## 7.7 Control Systems Not Required for Safety

The information in this section of the reference ABWR DCD, including all subsections and figures, is incorporated by reference with the following departures and supplements.

Figure 7.7-11 Simplified Functional Diagram of the Automatic Power Regulation System

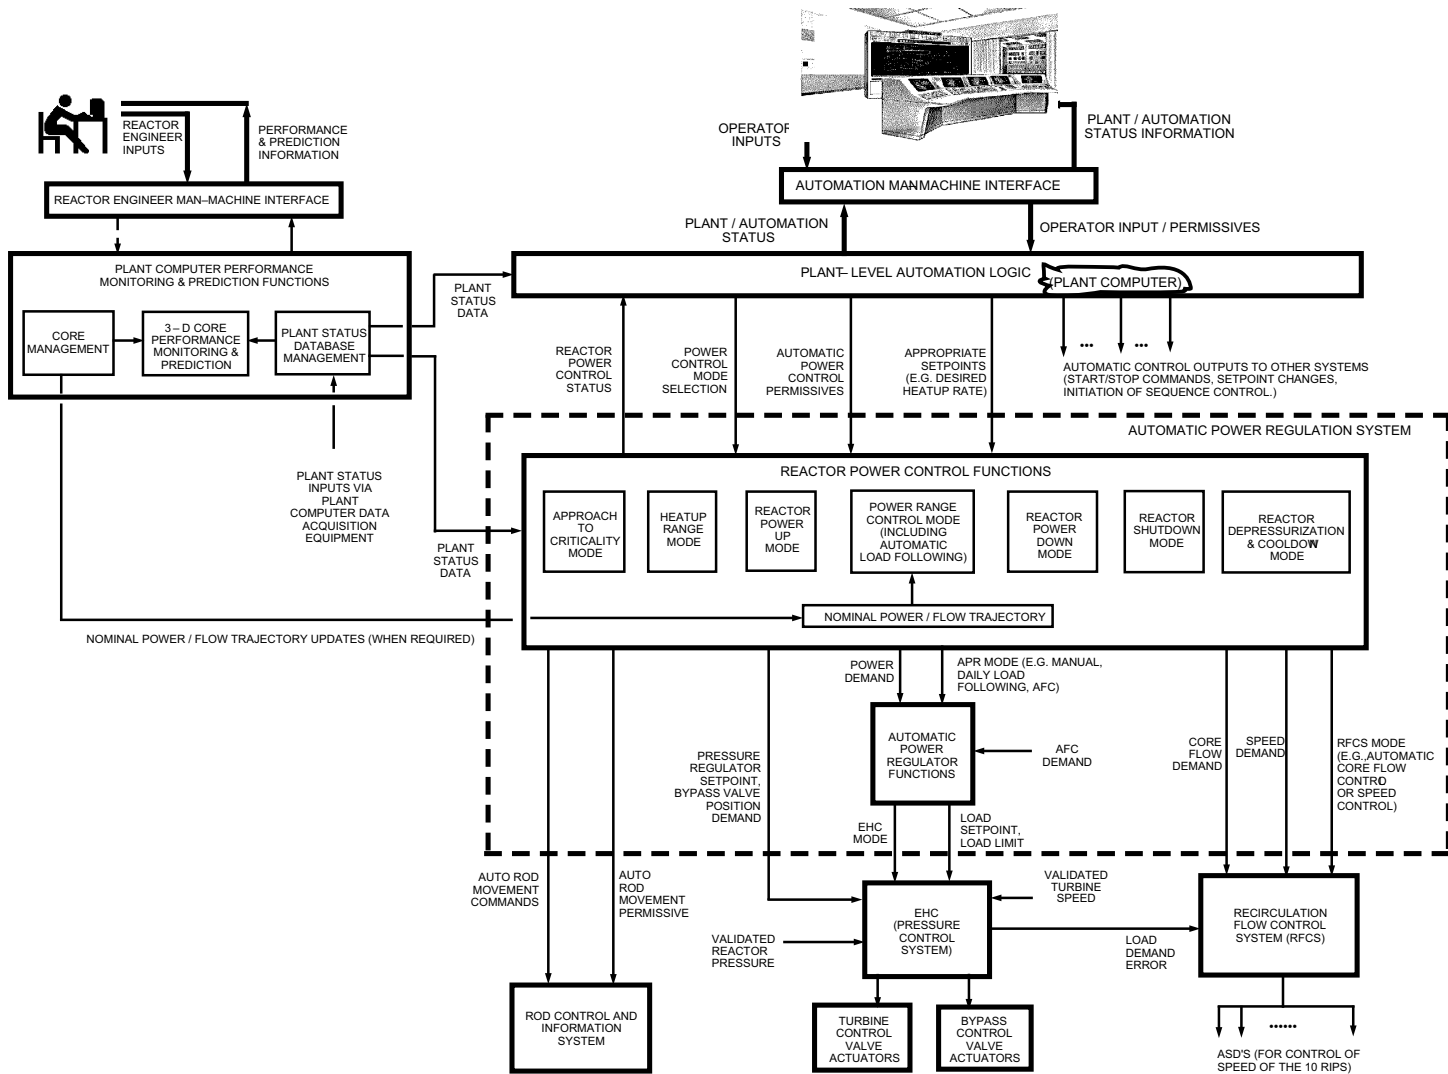
STD DEP T1 3.4-1 (Figures 7.7-4, 7.7-5, 7.7-8, 7.7-11)

Automatic power regulation is achieved by appropriate control algorithms for different phases of the reactor operation which include approach to criticality, heatup, reactor power increase, automatic load following, reactor power decrease, and reactor depressurization and cooldown. The APR System receives input from the ~~plant~~ process computer, the Power Generation Control System (Subsection 7.7.1.5.1), the Steam Bypass and Pressure Control System (Subsection 7.7.1.8), and the operator's control console. The output demand signals from the APR System are to the RCIS to position the control rods, to the RFC System to change reactor coolant recirculation flow, and to the SB&PC System for automatic load following operations. The PGS performs the overall plant startup, power operation, and shutdown functions. The APR System performs only those functions associated with reactor power changes and with pressure regulator setpoint (or turbine bypass valve position) changes during reactor heatup or depressurization. A simplified functional block diagram of the APR System is provided in Figure 7.7-11.
